**30-039-21432 AXI APACHE O #013**

**HILCORP ENERGY COMPANY**

Hilcorp Energy Company requests permission to temporarily abandon the PC wellbore for future potential. If the wellbore MIT does not pass, then Hilcorp Energy Company requests approval to plug and abandon the wellbore. Attached is current wellbore schematic, proposed TA and P&A schematic with procedure and reclamation plan. Pre-onsite inspection conducted 8/14/19.

HILCORP ENERGY COMPANY  
AXI APACHE O 13  
TA or P&A NOI

## AXI APACHE O 13 - PROPOSED P&amp;A WELLBORE SCHEMATIC

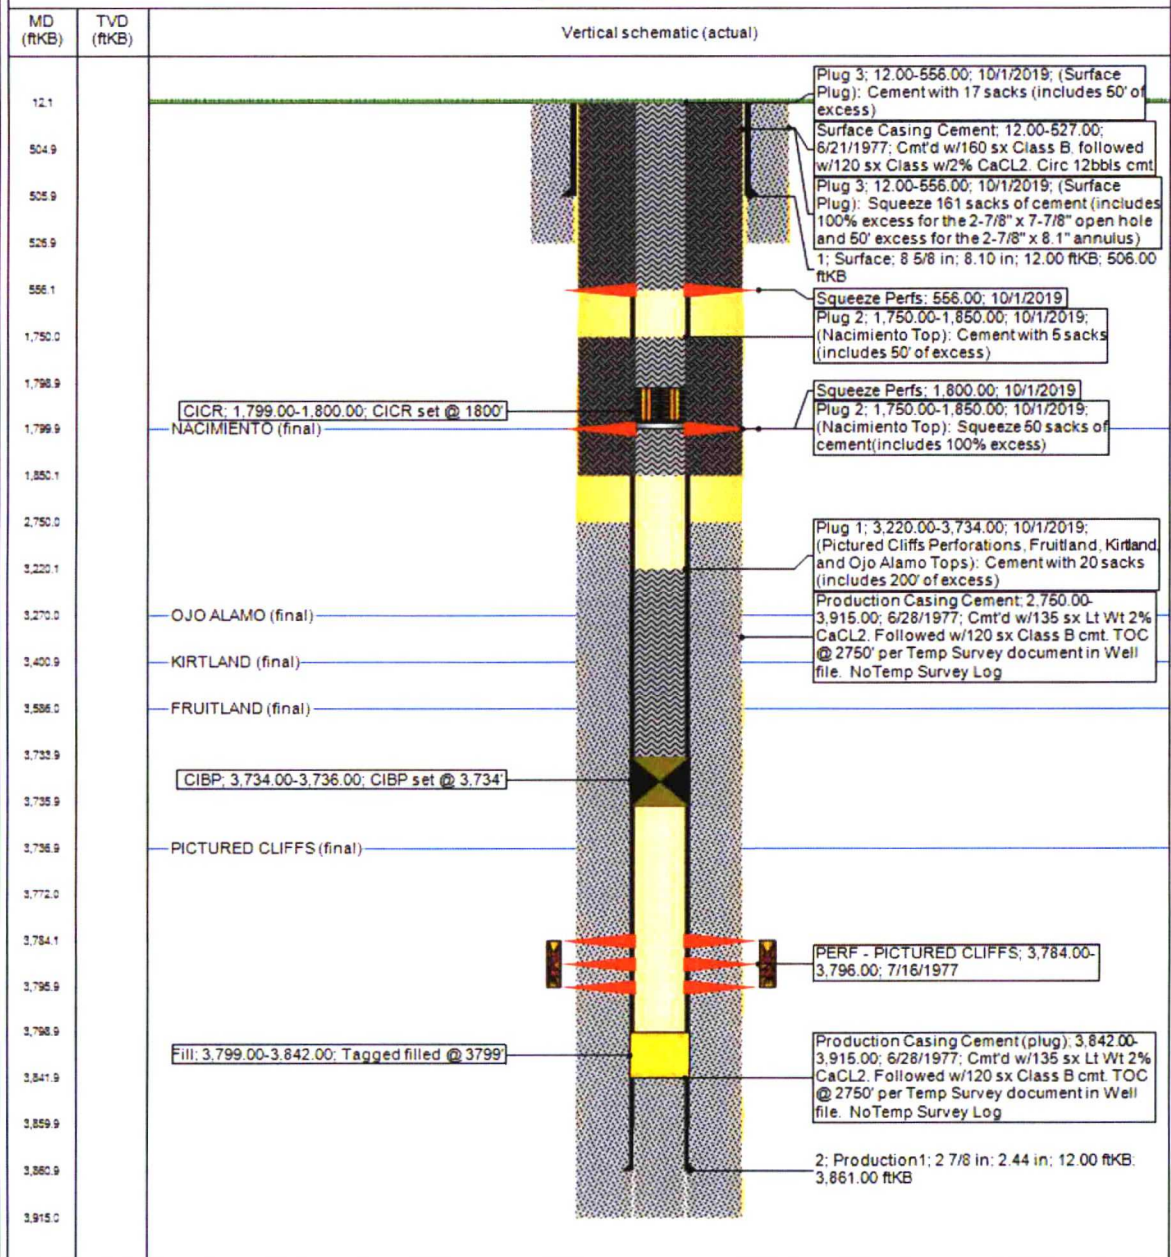
- Notify NMOCD 24hrs prior to beginning operations.
- Extend Plug #1: 3,734'-3,145'. OCD Ojo Alamo top: 3,195'
- Extend Plug #2: 1,850'-1,460'. OCD Nacimiento top: 1,510'.
